**Subject:** Catawba Nuclear Station Units 1 and 2; Docket Nos. 50-413, 50-414  
McGuire Nuclear Station Units 1 and 2; Docket Nos. 50-369, 50-370  
Partial Response to Request for Additional Information Regarding the Use of  
Mixed Oxide Lead Fuel Assemblies

**Reference:** NRC Letter dated July 25, 2003, Request for Additional Information Re: Mixed  
Oxide Lead Fuel Assemblies (TAC Nos. MB7863, 7864, 7865, 7866)

Attachment  
Partial Response to NRC Staff Request for  
Additional Information dated July 25, 2003

Figure Q13-1  
Loop Noding Diagram

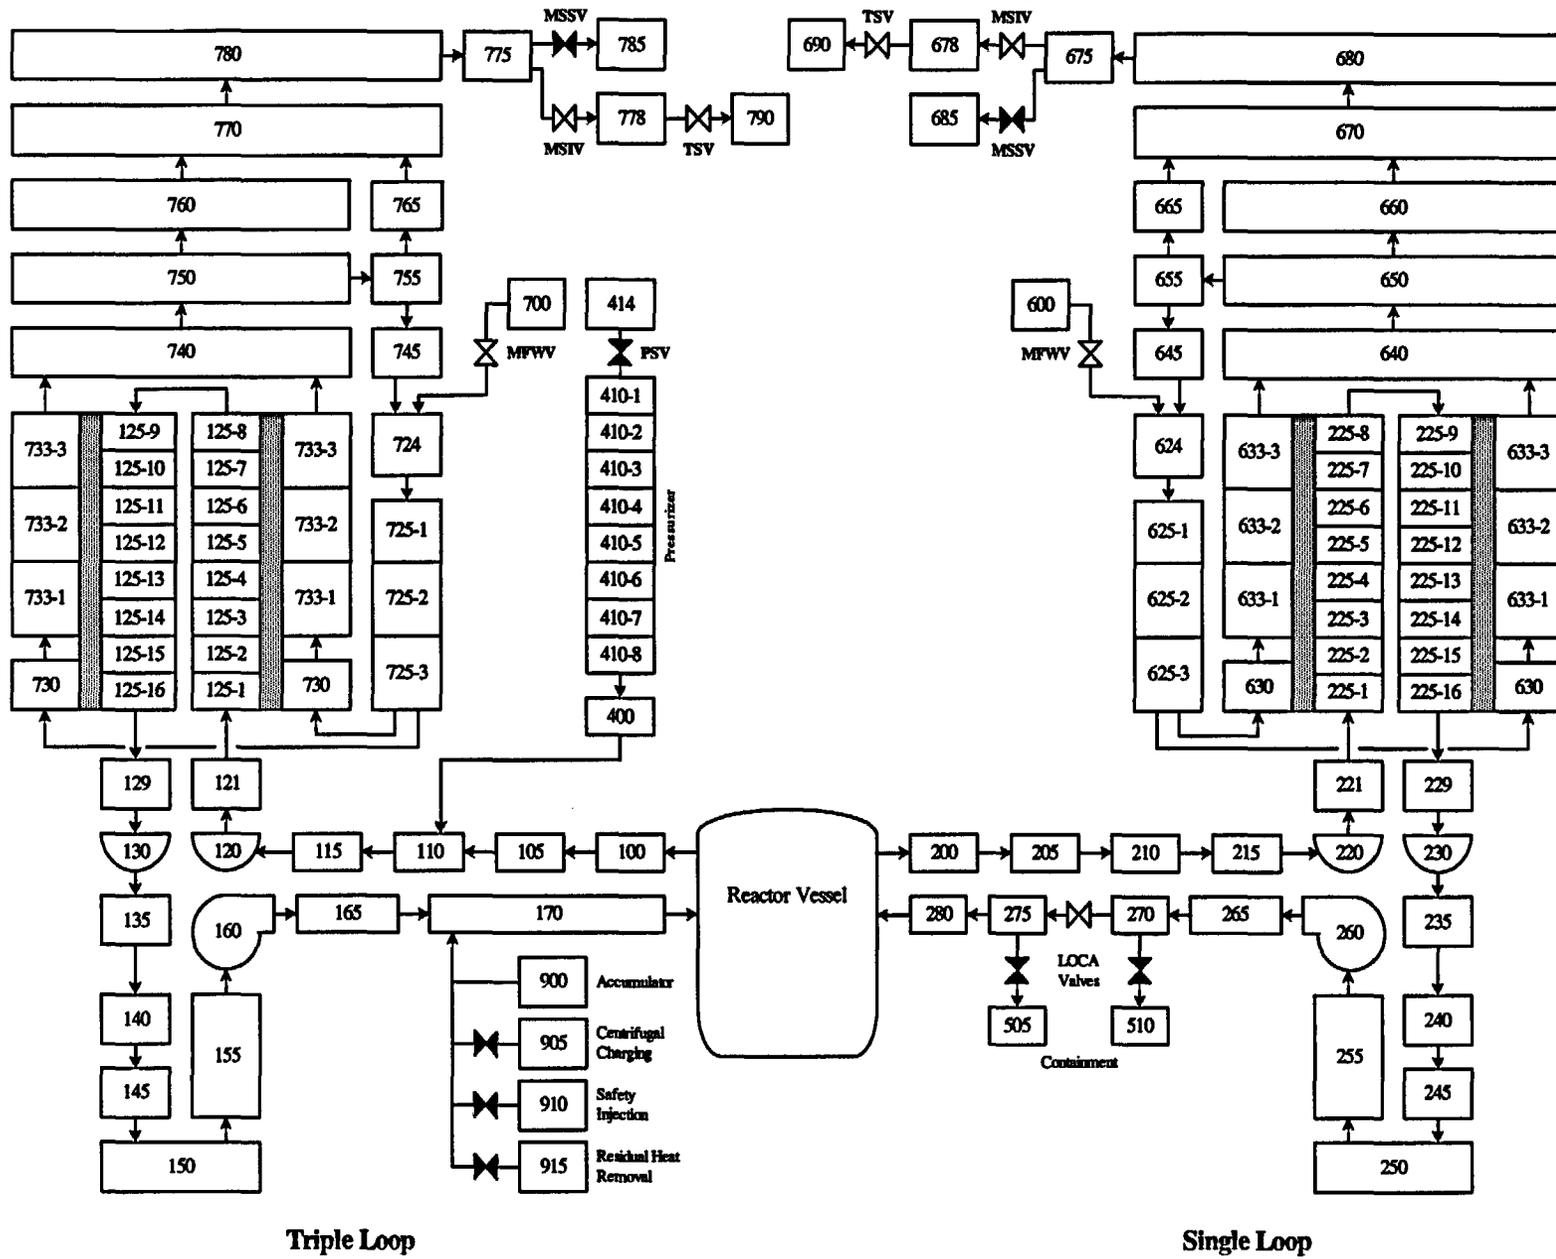
13. To allow the NRC staff to perform confirmatory analysis, please provide both the McGuire and Catawba loss-of-coolant accident (LOCA) input decks for the low enriched uranium (LEU) as well as the MOX fuel rods. Provide the decks in an electronic format, including nodalization diagrams.

Figures Q13-1 and Q13-2 are node diagrams for the decks. Figure Q13-1 shows the loop node arrangement while Figure Q13-2 shows the reactor vessel node arrangement. Figure 3-5 of Attachment 3 to Reference Q13-1 provides some additional detail specific to the core region.

**Figure Q14-1**  
**MOX Fuel Lead Assembly Total Core Peaking Factor**

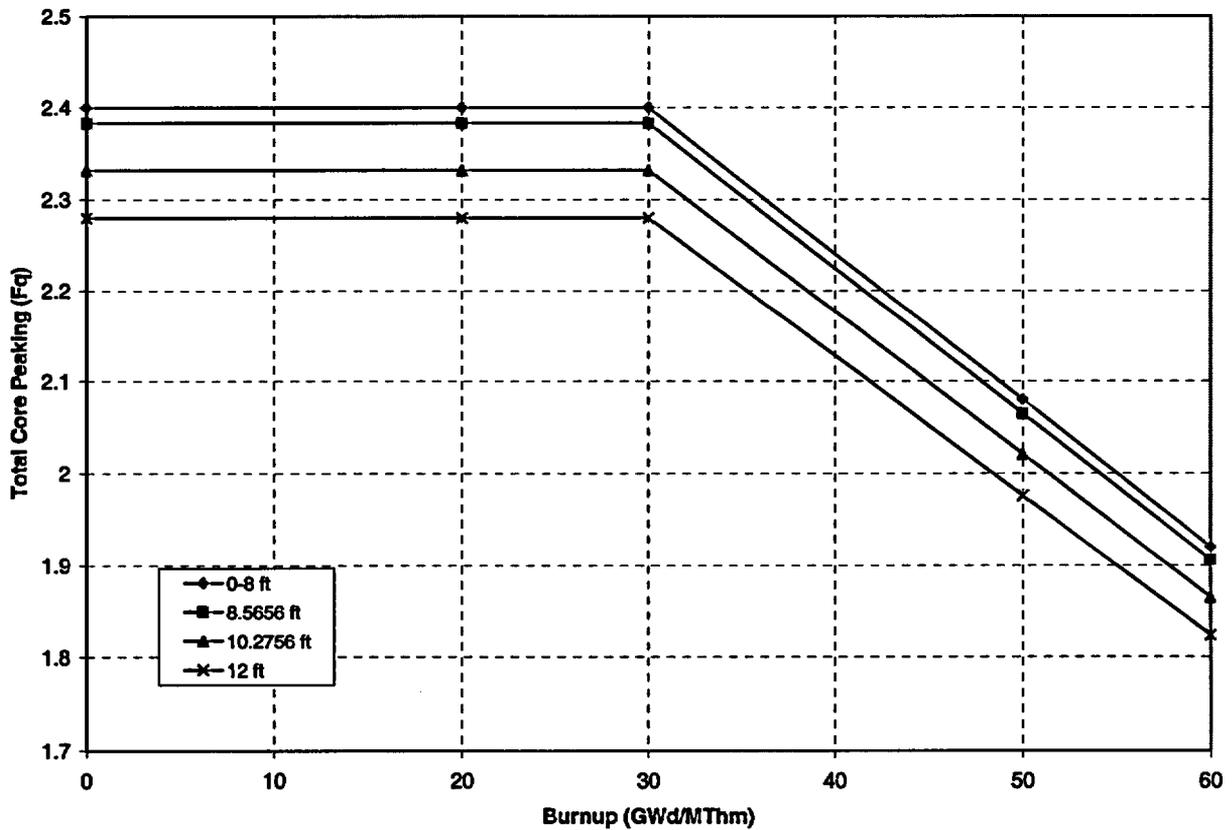
14. Provide the reference to the best estimate LOCA model noted in section 3.7.1.7.

A summary of the sensitivity cases is provided in Table Q14-1. The resulting LOCA peaking requirements for the MOX fuel lead assemblies are shown in Figure Q14-1. These peaking requirements will assure that the MOX fuel will comply with the regulatory limits for LOCA as provided in the response to Reactor System RAI Question 12.

Figure Q18-1  
MOX Fuel and LEU Fuel Colorsets

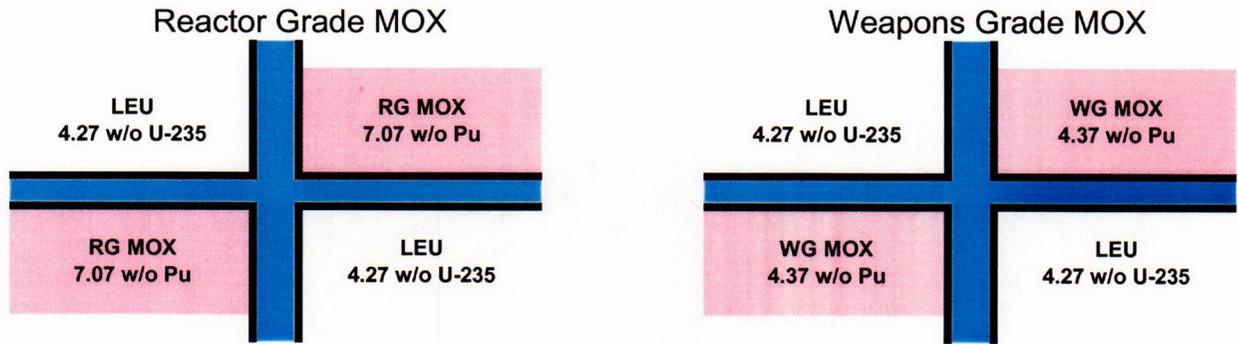
18. In sub-section 3.7.1.1.1, nothing is mentioned about the MOX/LEU interface behavior. Provide a qualitative and quantitative discussion regarding the neutron flux behavior at the interface of the MOX and LEU fuel assemblies.

Duke used the CASMO-4 computer code to model pin cell neutron flux and power at the intersection of four quarter-assembly lattices. These "colorsets" provide detailed two dimensional neutronic calculations that account for interface effects between dissimilar fuel assemblies. MOX fuel assemblies and LEU fuel assemblies of equivalent lifetime reactivity were placed in a checker board arrangement to simulate face adjacent MOX and LEU fuel assemblies (see Figure Q18-1). Two cases were considered – one using MOX fuel with weapons grade (WG) plutonium isotopics, and another using MOX fuel with reactor grade (RG) plutonium isotopics. The lead assemblies will be WG MOX fuel; the RG MOX fuel

Figure Q20-1  
Impact of MOX Fuel Loading and Burnup on  
Effective Delayed Neutron Fraction ( $\beta_{eff}$ )

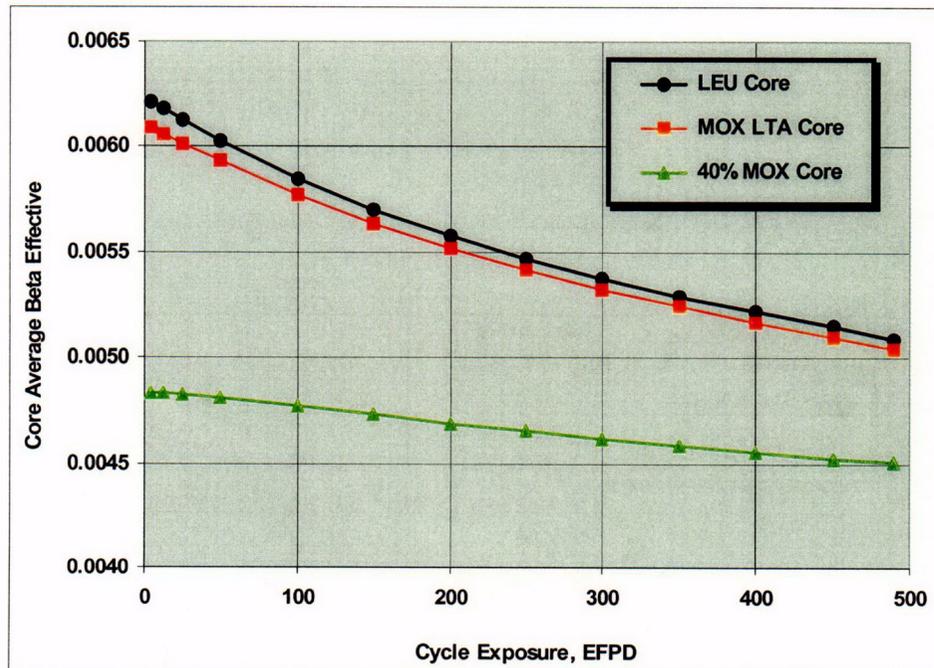
20. Also, in the second paragraph of sub-section 3.7.1.1.1, the change in the delayed neutron fraction is discussed at beginning of life. However, the behavior of the delayed neutron fraction at middle of life and end of life is not addressed. Provide a discussion on the delayed neutron factor change with respect to burnup.

Table Q20-1 and Figure Q20-1 show the variation in core average effective delayed neutron fraction ( $\beta_{eff}$ ) with cycle burnup and MOX fuel loading. The introduction of four MOX fuel lead assemblies results in a minor decrease in beginning of cycle (BOC)  $\beta_{eff}$ . The impact on end of cycle (EOC)  $\beta_{eff}$  is even smaller. The 40% MOX fuel core sees a more significant reduction in  $\beta_{eff}$  at BOC, but the change in  $\beta_{eff}$  with burnup is much smaller than the corresponding change in a core containing all low enriched uranium (LEU). The result is that the 40% MOX fuel core has more uniform kinetics over the cycle.
